APPENDIX H

Peer Review Record

Golder Comments on Version R0A (letter dated June 7, 2010)		Geofirma Response
General		
1	With respect to the WHPA, in our opinion (from the information provided) there remains a high degree of uncertainty with respect to their extent and the groundwater times of travel to the supply well. This is in contrast to the low uncertainty classification concluded by Geofirma on page 26 of the report.	Based on the comment, and on further work done to address the comment, WHPA Zones B and C were assigned a high uncertainty rating, due to their strong dependence on bedrock porosity, a highly uncertain value.
WHPA and Vulnerability Mapping		
1	Section 2.2, paragraph: States that the sewage treatment ponds were constructed with an "impermeable clay liner". Considering the proximity of the treatment ponds to the supply wells and their estimated capture zones, the hydraulic performance of the liners is of interest. In Section 2.3.1 Geofirma indicates that faecal coliform bacteria was detected in shallow overburden monitoring wells located near the ponds and attributes the presence of the bacteria in the monitoring wells to adjacent farming practices. Additional de

Figure 1 Sandstone Thickness as Used to Construct the Groundwater Flow Model

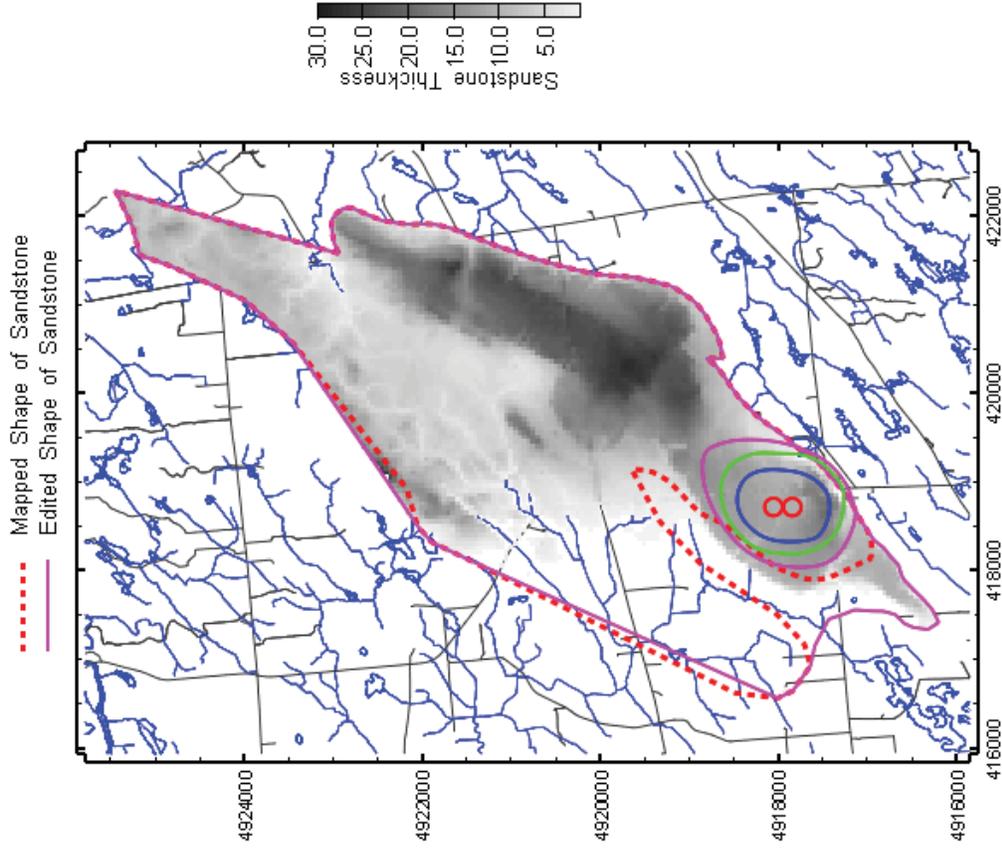
<p>Nepean area, and identifies it as “Potsdam Gp.; Nepean Fm.; Covey Hill Fm.”. The second shows the two southern portion, identifying them as “Nepean” and “Potsdam”. It would appear that the grouping of these areas in the most recent version of the report is acceptable, and that they are the same formations. Attached is the metadata for the mapping files, the Bedrock Geology layer of Ontario, and the Paleozoic Geology layer of Ontario.</p> <ul style="list-style-type: none"> • Ant noted that the geology areas are thin layers, and may not make a difference to the model overall. Ant was also going to check the details of that data. 	<p>(see Figure 3.1 in the report) which was felt to be as accurate a indicator of sandstone presence as the geological mapping, which appeared then, as now, to be subject to error. Importantly, Figure 1 indicates that the sandstone thickness in the entire westerly lobe of the mapped “Nepean/Potsdam” was modelled with zero thickness, which is consistent with the idea that this western lobe may in fact be conglomerate.</p>

Figure 2 Analysis of Water Well Data Used in the Lansdowne Study

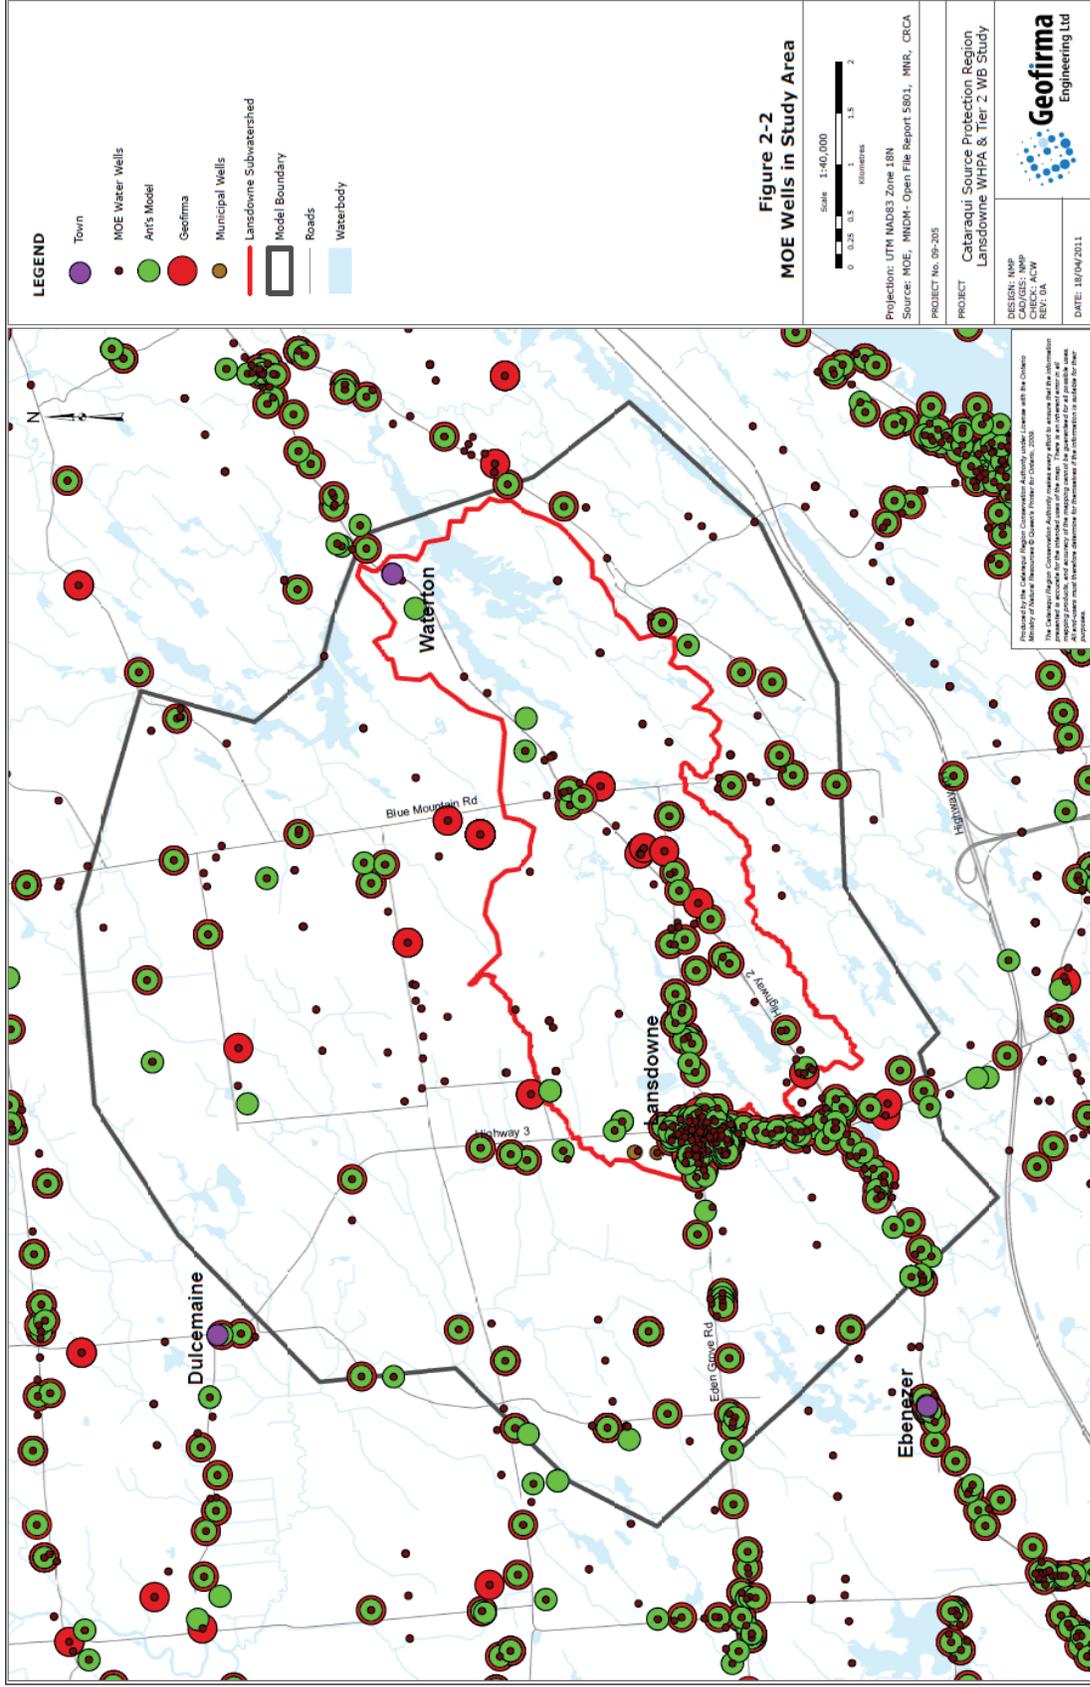
7	<ul style="list-style-type: none"> Brian asked about including a water table contour map from the raw data, showing the well record levels, and the simulated contours on top. 	<p>The requested map of contoured hydraulic head from the WWIS has been included (Figure 5-1). Inclusion of the simulated hydraulic heads on this figure would make it very difficult to read.</p>
8	<ul style="list-style-type: none"> Brian asked about Figure 5-4, and whether all wells with water levels are included. And if so, why do so many more wells appear on Figure 2-2? Ant noted it must be that many of the 2-2 wells don't have water levels, so aren't shown on 5-4. 	<p>Figure 2 provides an explanation for the differences between Figure 2-2 and Figure 5-4. The green dots are calibration targets in the model (based on the MOW WWIS, unmodified by CRCA). The large red dots are wells included in the CRCA version of the database with enough information to support their use as calibration targets, and the small brown dots are all wells included in the CRCA version of the database regardless of their data quality and completeness. (Small brown dots on their own represent wells with missing information that cannot be used as calibration targets.) There are perhaps 4 potential calibration targets that could provide information to the model (i.e., are in areas not well covered by the green dots), but this additional information would not be sufficient to support any changes to the model, and would not influence WHPA delineation. Incorporation of these few additional data into the model is not justified at this time.</p>
